AGENDA PORTLAND PLANNING BOARD MEETING

To: Brandon Mazer, Chair and Members of the Portland Planning Board
From: Caitlin Cameron, Urban Designer
Date: Friday, April 9, 2021
Re: 200 Federal Street; Level III Site Plan, Subdivision, and Inclusionary Zoning Conditional Use application
Project #: PL-001235-2020
CBL: 032 G001001
Meeting Date: April 13, 2021

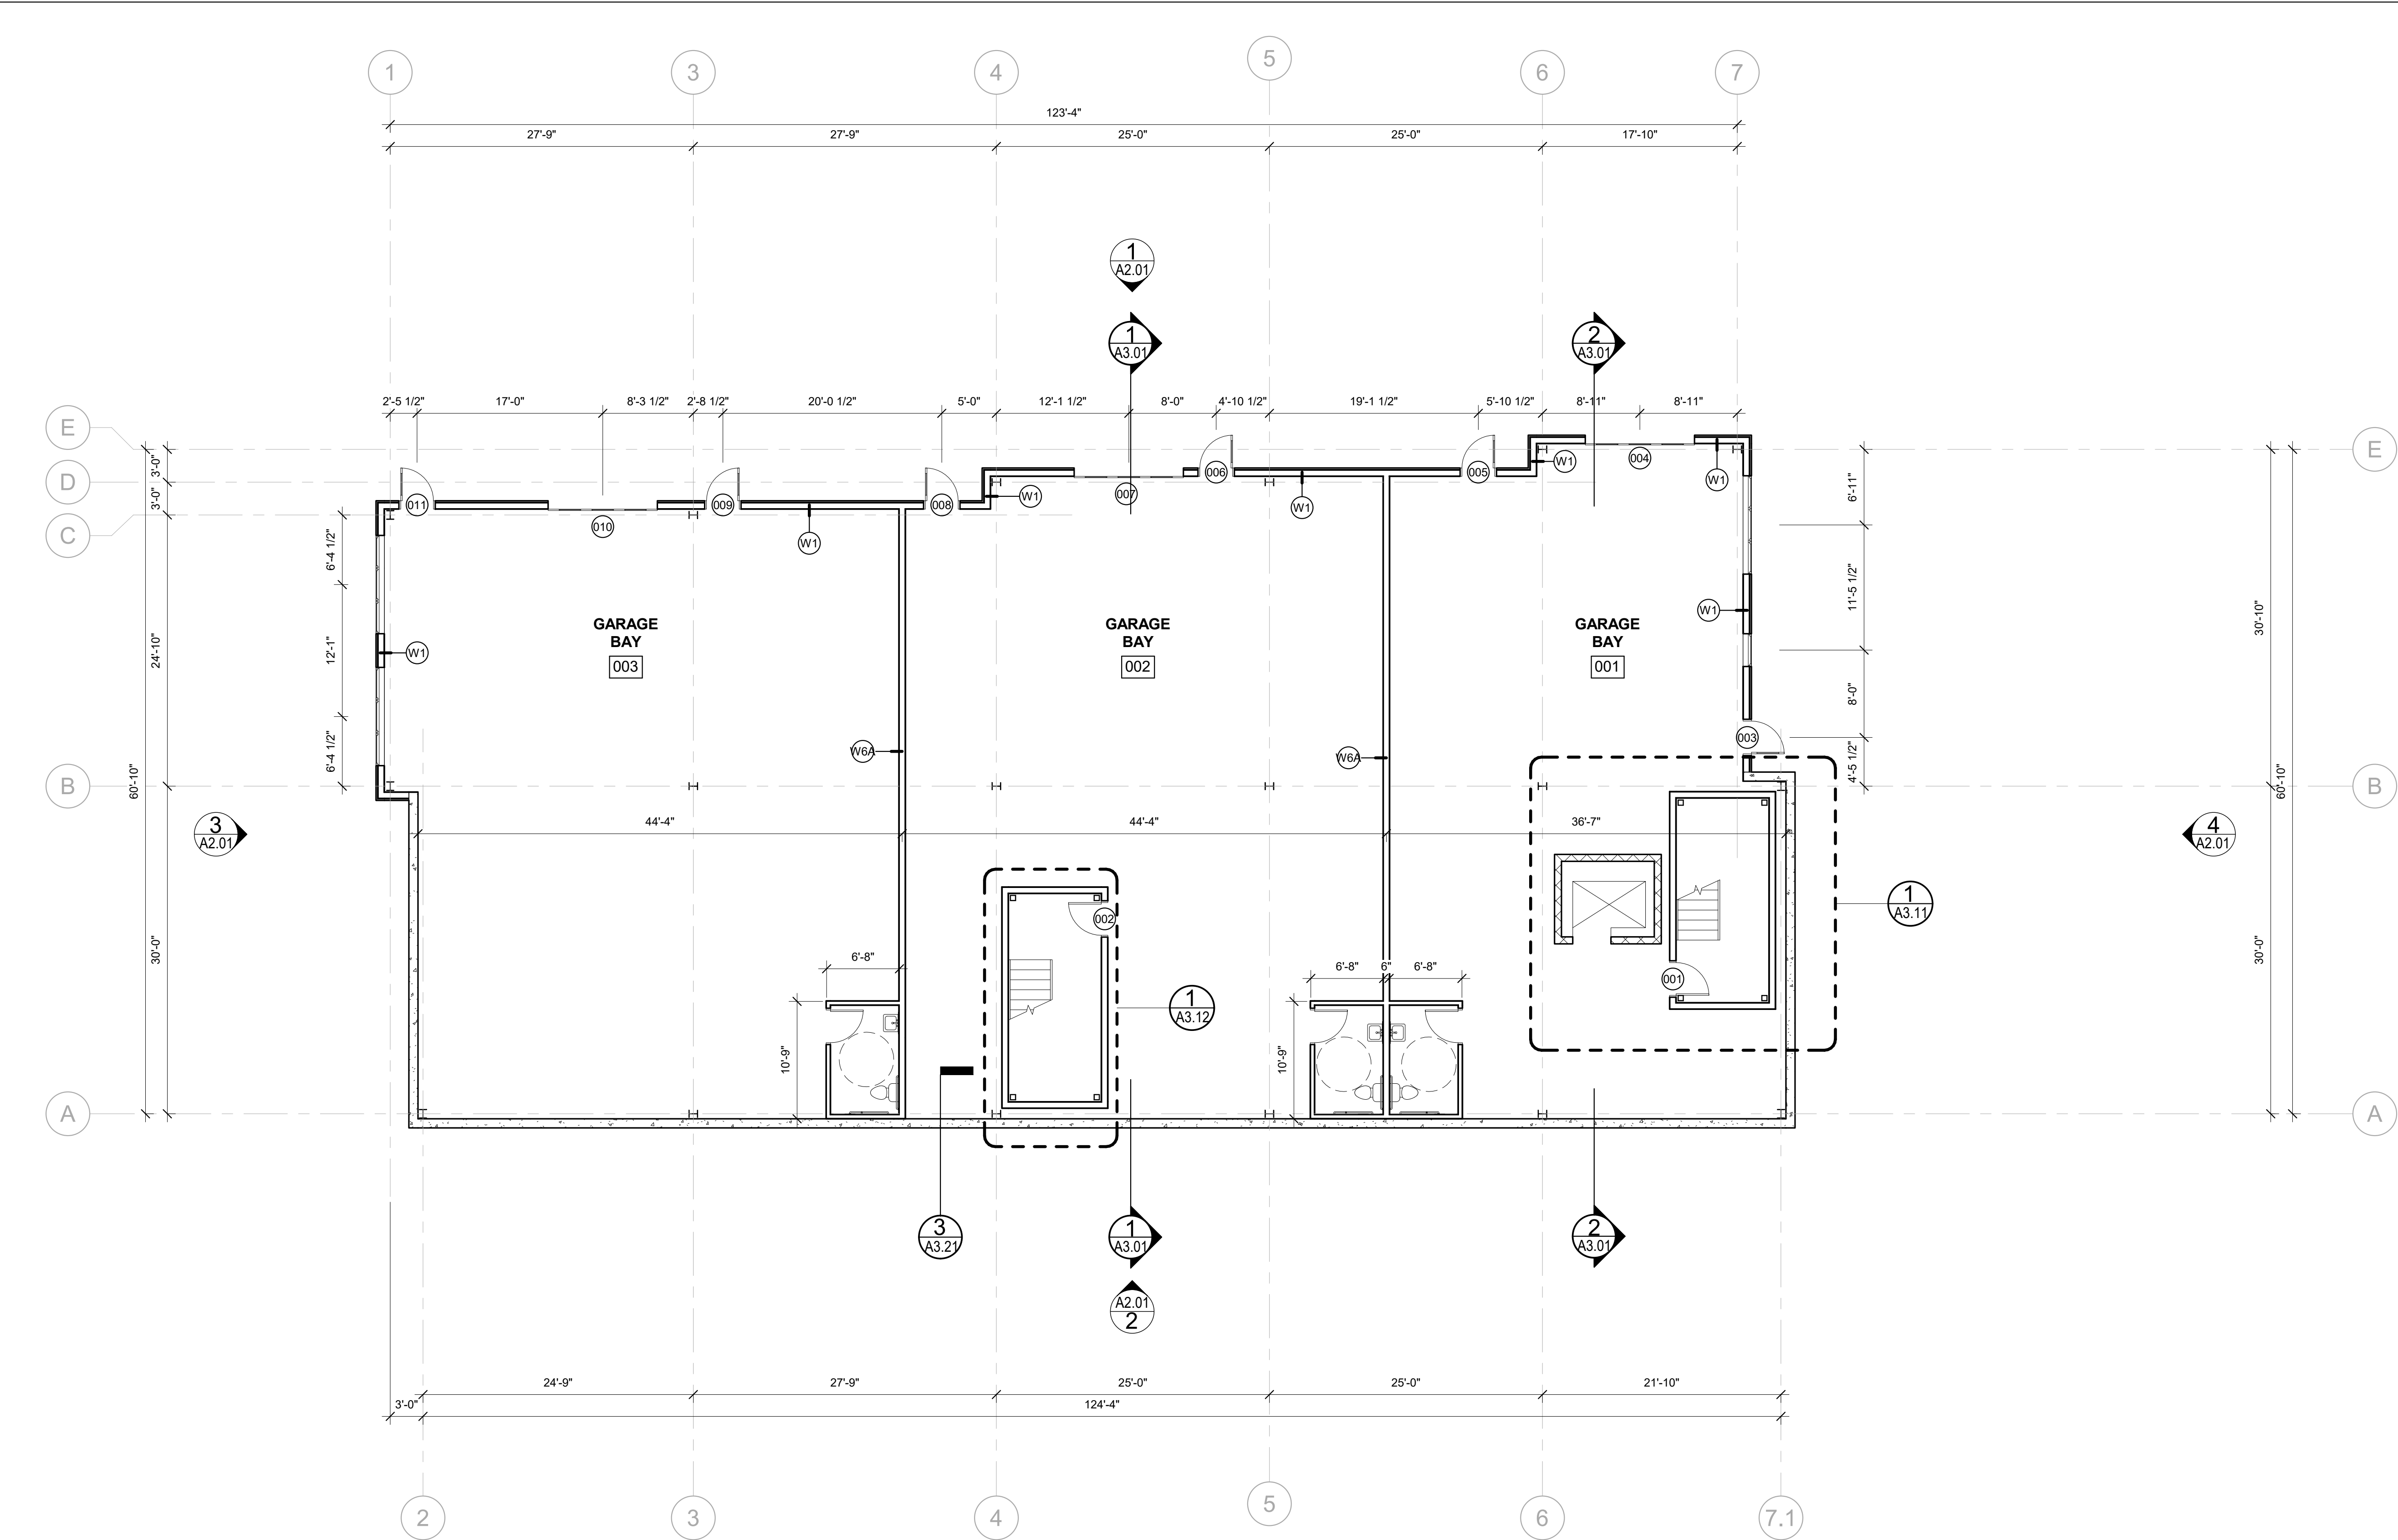
- 4. The basement plan, sheet A1.00 divides the space up into 3 tenants. The use is labeled office, industrial. Office is not a permitted use in the zone and industrial is pretty vague. Can you ask them if they have specific tenants in mind?*

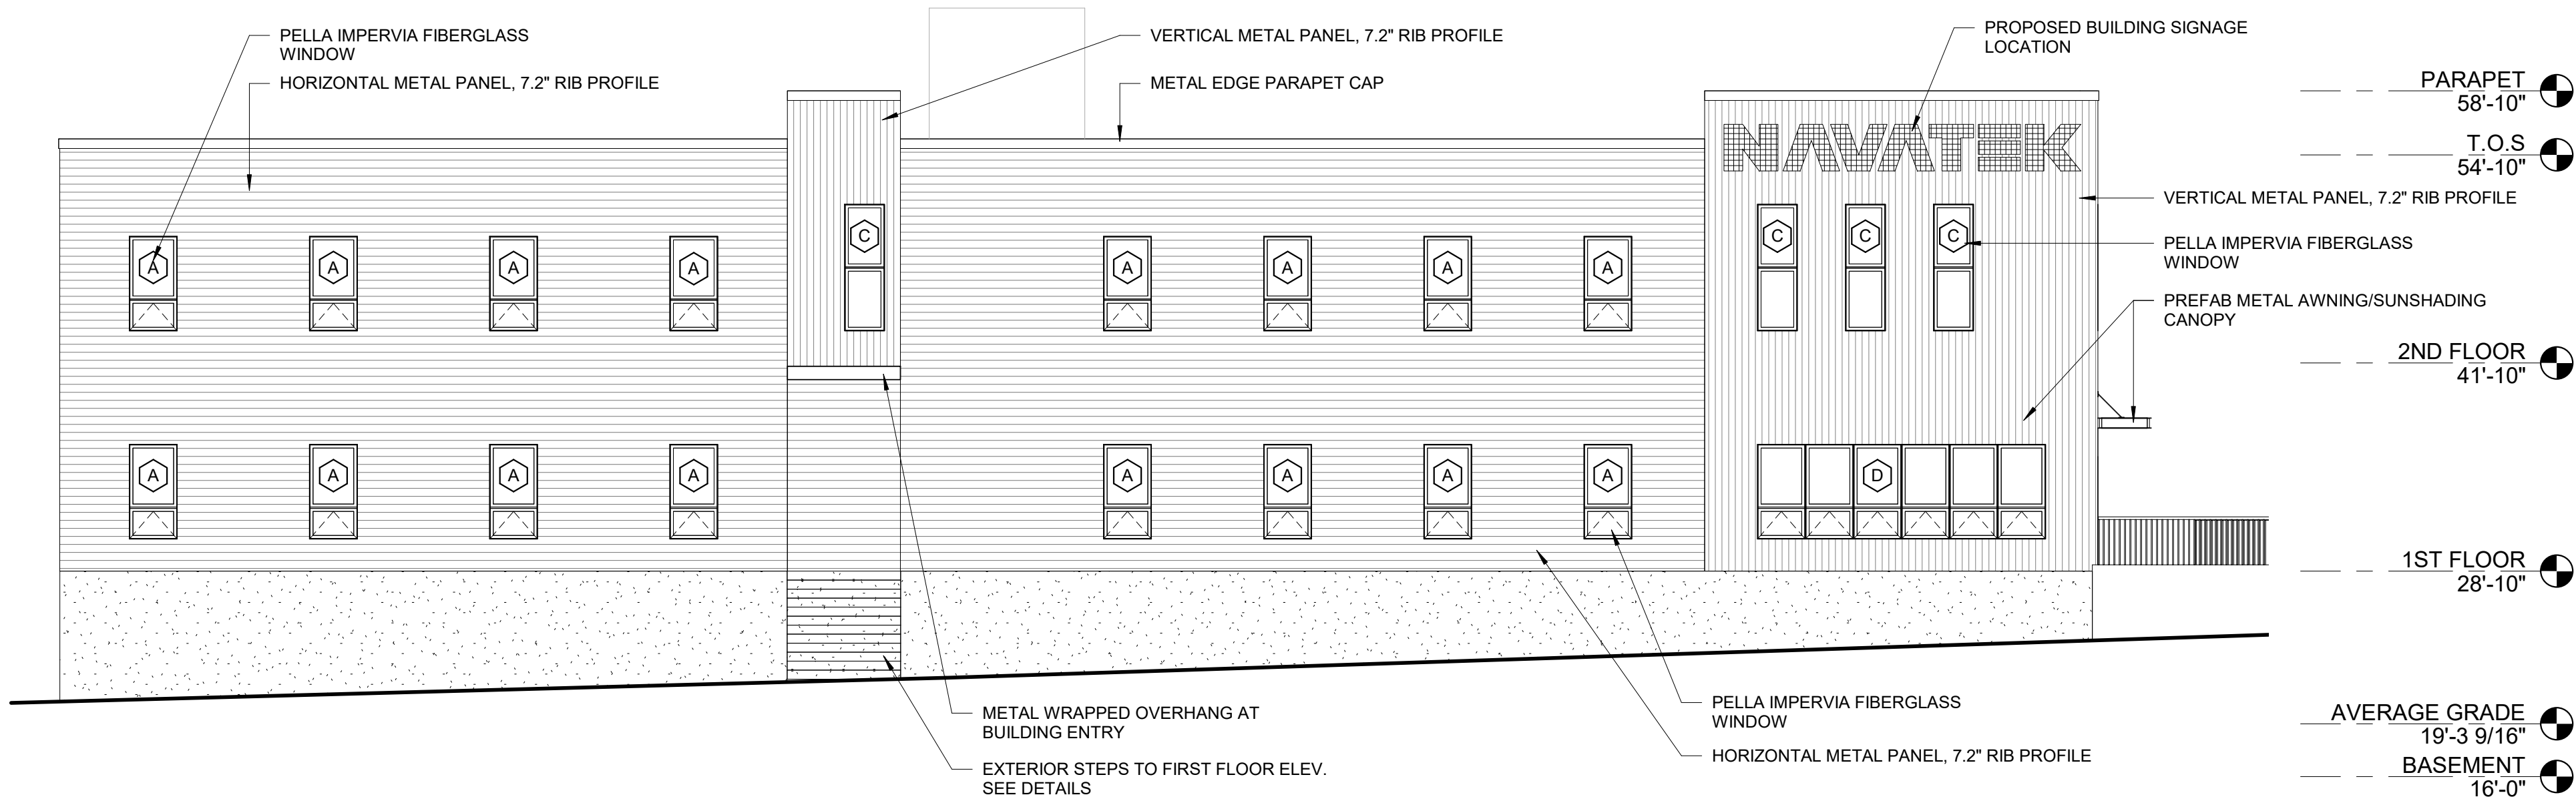
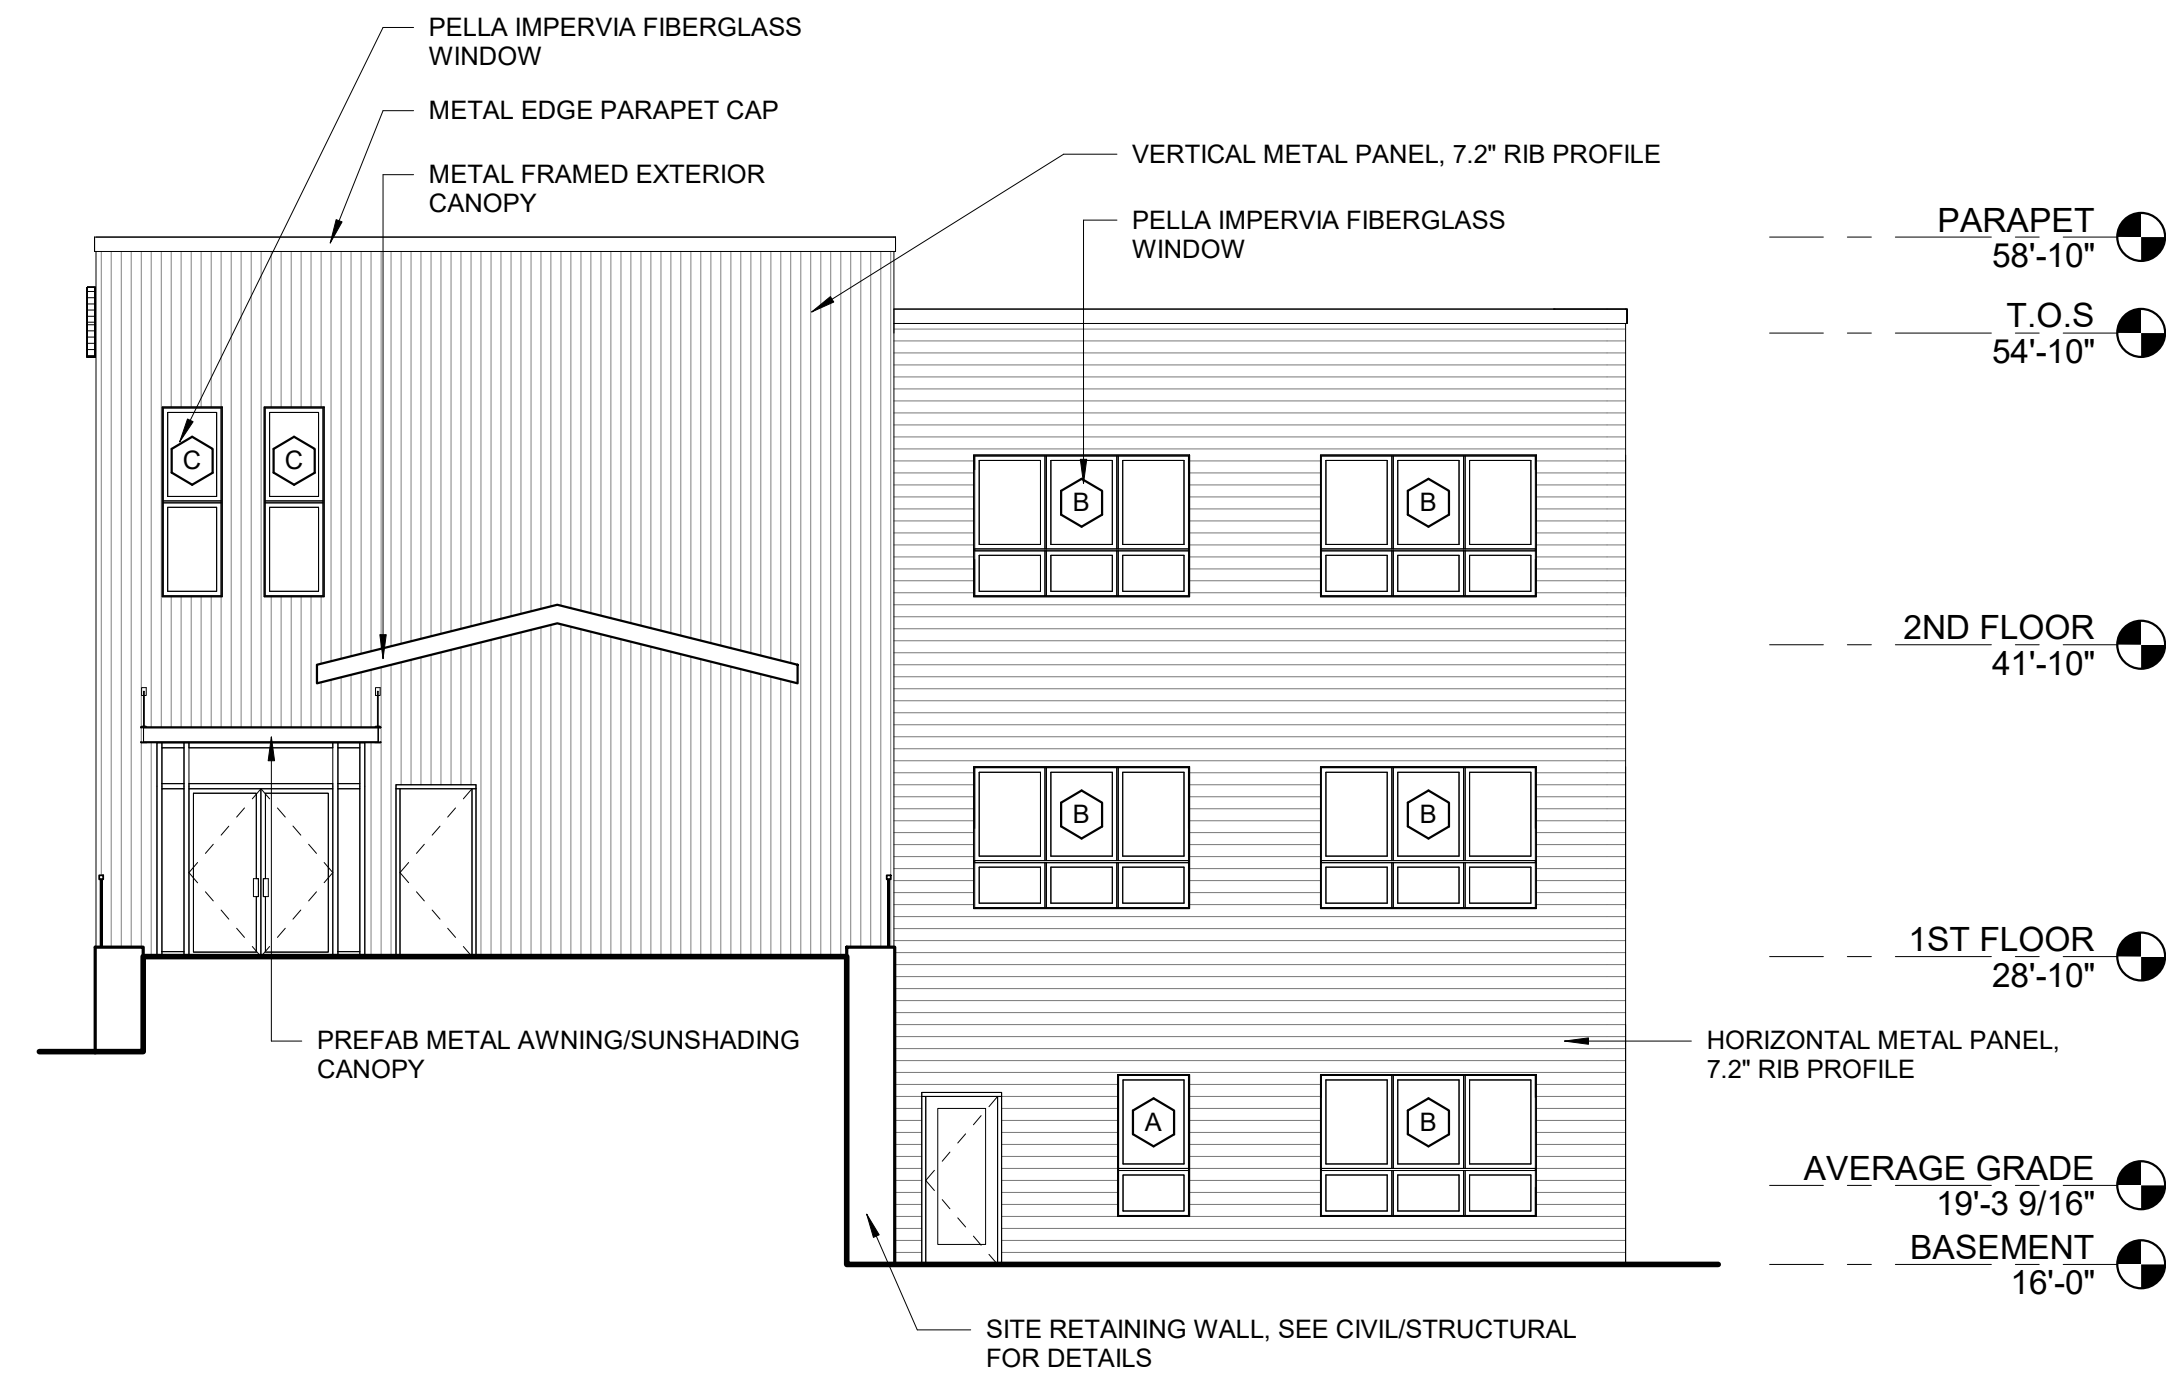
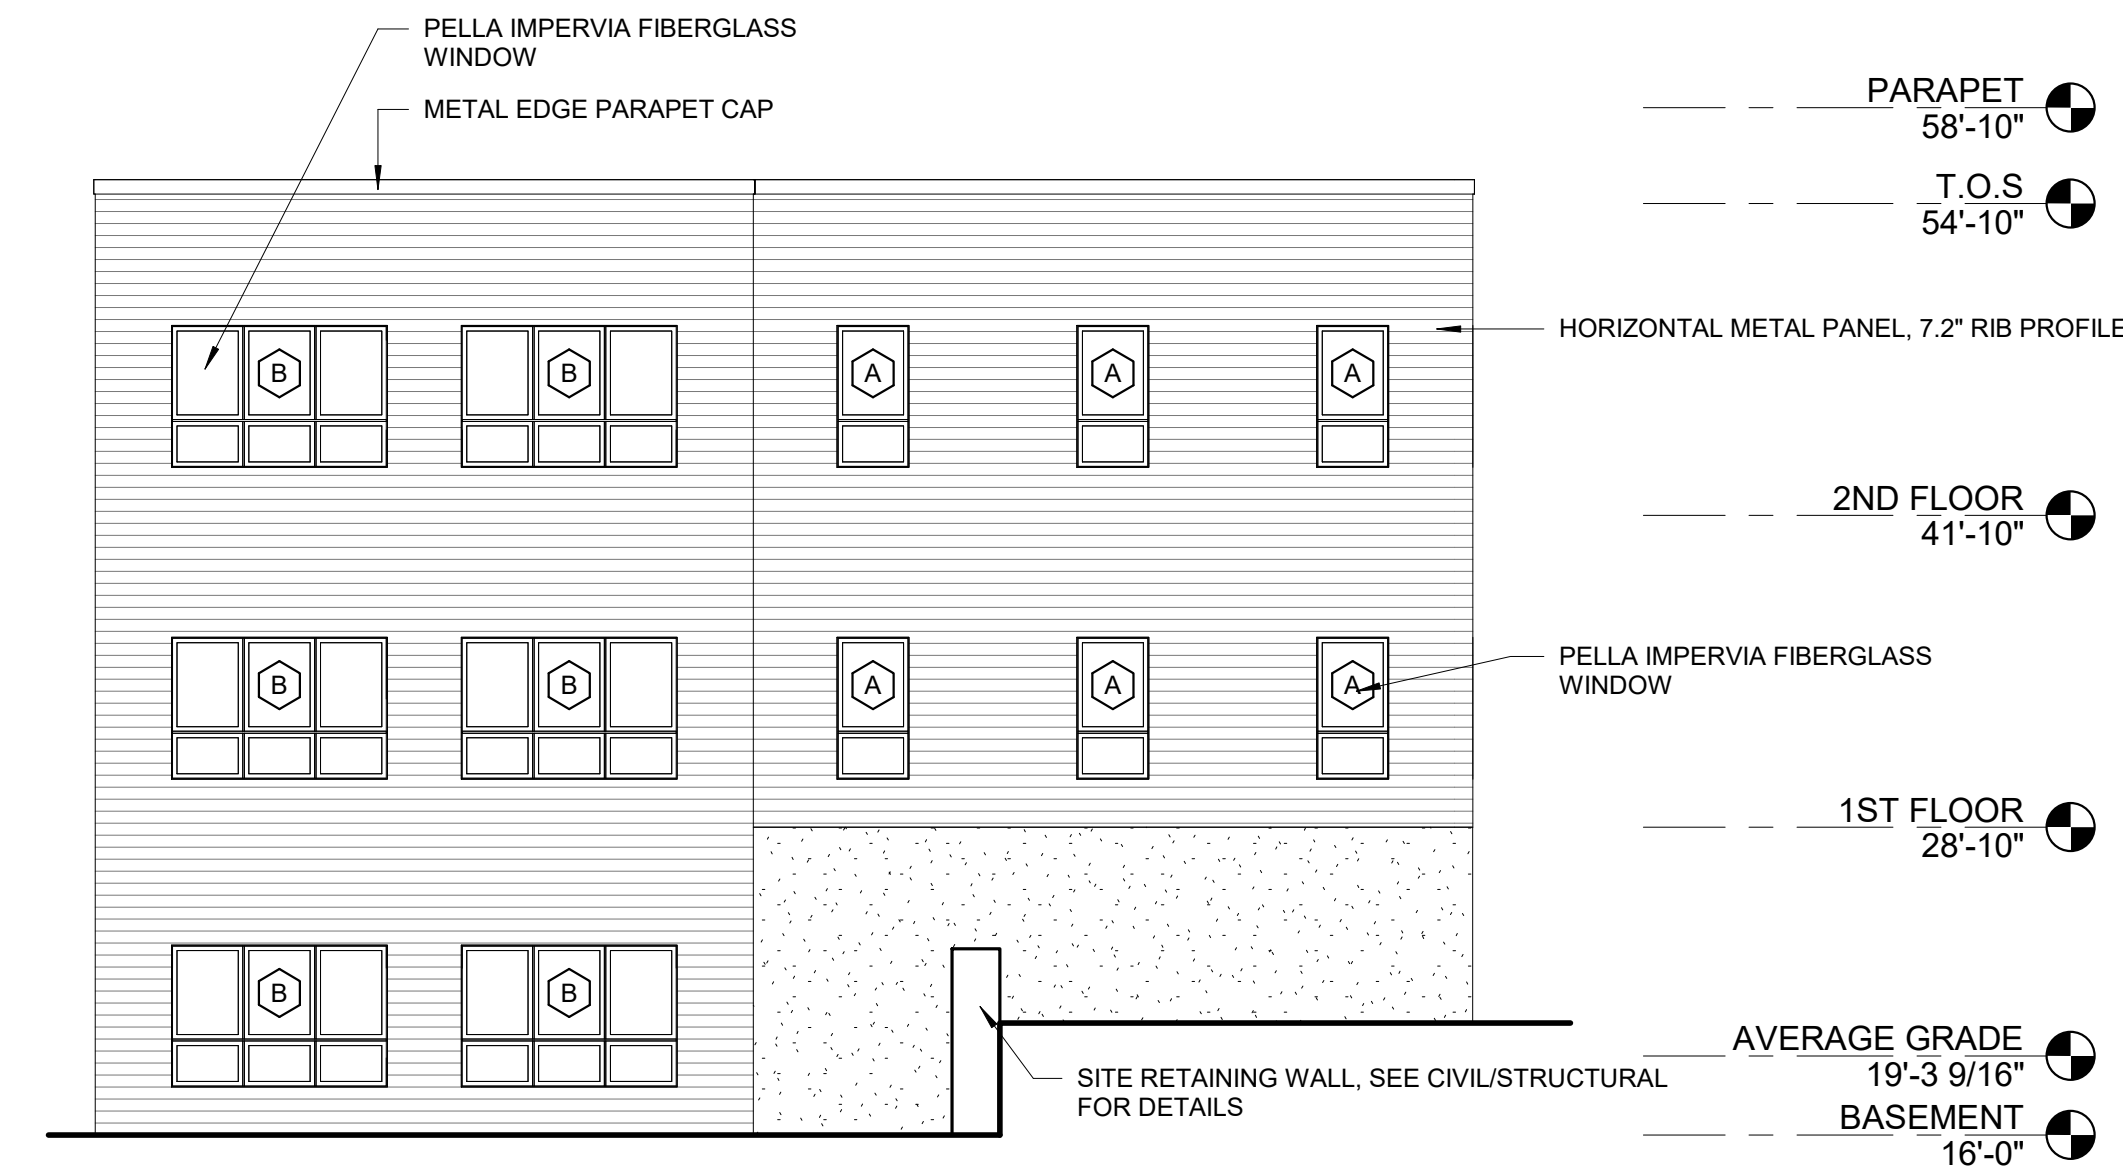
- 3. The average grade of 19.295' provided on Plan A1.00, needs to be shown on the elevation plan, A2.01.*

Response: A revised Plan A2.01 has been prepared and uploaded to ePlan and a copy also accompanies this letter.
